CITY OF ALBUQUERQUE

September 20, 2022

Re: McDonald
1901 Ladera Dr. NW
Traffic Circulation Layout
Engineer's Stamp 05-24-22 (H09-D020)

Based upon the information provided in your submittal received 08-23-22, the above referenced plan cannot be approved for Building Permit until the following comments are addressed:

C4.1 TRAFFIC CIRCULATION PLAN

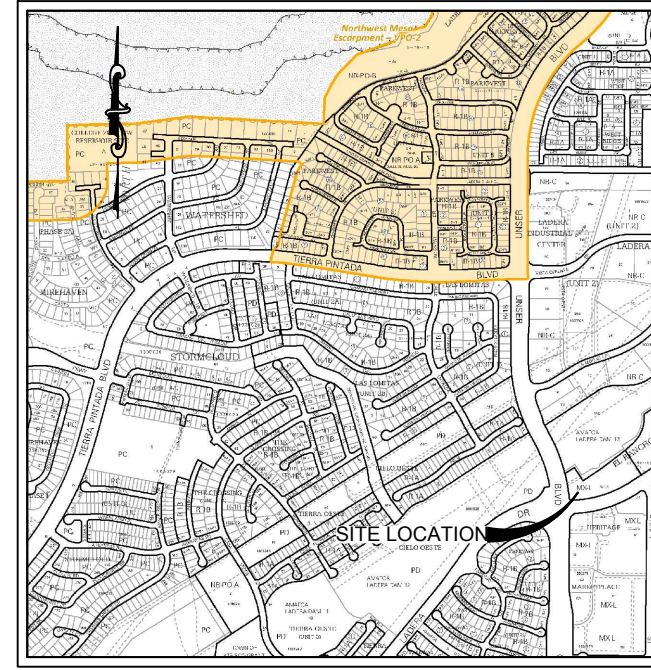
1. Please revise the site plan and correct the address from 7943 Ladera to 1901 Ladera.
2. Provide approved plat action and/or approved shared access easement.

3. The width for 60 degree angled parking should be min. 9.8 ft.
4. Please reference COA std dwg 2426 for both proposed driveway accesses.
5. Sidewalk connectivity at the east side of the site need to be provided.

6. Provide the width for the existing sidewalk.
7. The ADA accessible parking sign must have the required language per 66-7-352.4C NMSA 1978 **"Violators Are Subject to a Fine and/or Towing."** Please call out detail and location of signs.

8. The ADA access aisles shall have the words **"NO PARKING"** in capital letters, each of which shall be at least one foot high and at least two inches wide, placed at the rear of the parking space so as to be close to where an adjacent vehicle's rear tire would be placed. (66-1-4.1.B NMSA 1978)

9. Provide details for all the proposed signs and pavement marking.
10. ADA curb ramps must be updated to current standards and have truncated domes installed for the driveway access off Ladera Dr.

11. Motorcycle parking spaces shall be designated by its own conspicuously posted upright sign, either free-standing or wall mounted per the zoning code.

12. The pavement marking "MC" should be shown in the opposite direction for motorcycles entering the parking space.
13. All bicycle racks shall be designed according to the following guidelines:

14. Bicycle racks shall be sturdy and anchored to a concrete pad.
 15. A 1-foot clear zone around the bicycle parking stall shall be provided.
 16. Bicycle parking spaces shall be at least 6 feet long and 2 feet wide.

17. Refuse vehicle maneuvering shall be contained on-site. The refuse vehicle shall not back into the public right of way. provide a copy of refuse approval.

18. Provide a copy of Fire Marshal approval.
 19. It is not apparent what type of pavement surface is being proposed. A hard driving surface will be required as part of this proposed project for parking area and drive aisles.

20. All one-way drives shall have "One Way" and "Do Not Enter" signage and pavement markings. Please show detail and location of posted signs and striping.

21. The minimum drive through lane width is 12 feet with a 25 foot minimum radius (inside edge) for all turns. (A 15 foot radius can be used with an increase in lane width to 14 feet). Please dimension all lane widths and radii.

22. Please provide a sight distance exhibit
 23. Show the clear sight triangle and add the following note to the plan: "Landscaping and signage will not interfere with clear sight requirements. Therefore, signs, walls, trees, and shrubbery between 3 and 8 feet tall (as measured from the gutter pan) will not be acceptable in the clear sight triangle. At both proposed driveway accesses.

24. Show the clear Intersection sight triangle and add the following note to the plan: "Landscaping and signage will not interfere with clear sight requirements. Therefore, signs, walls, trees, and shrubbery between 3 and 8 feet tall (as measured from the gutter pan) will not be acceptable in the clear sight triangle. See attached Intersection sight triangle requirements.

25. Please specify the City Standard Drawing Number when applicable.
 26. Shared Site access: driveways that straddle property lines, or are entirely on one property but are to be used by another property, shall have an access easement. Please include a copy of your shared access agreement with the adjacent property owner.

27. Add a note stating "All broken or cracked sidewalk must be replaced with sidewalk and curb & gutter." A build note must be provided referring to the appropriate City Standard drawing.
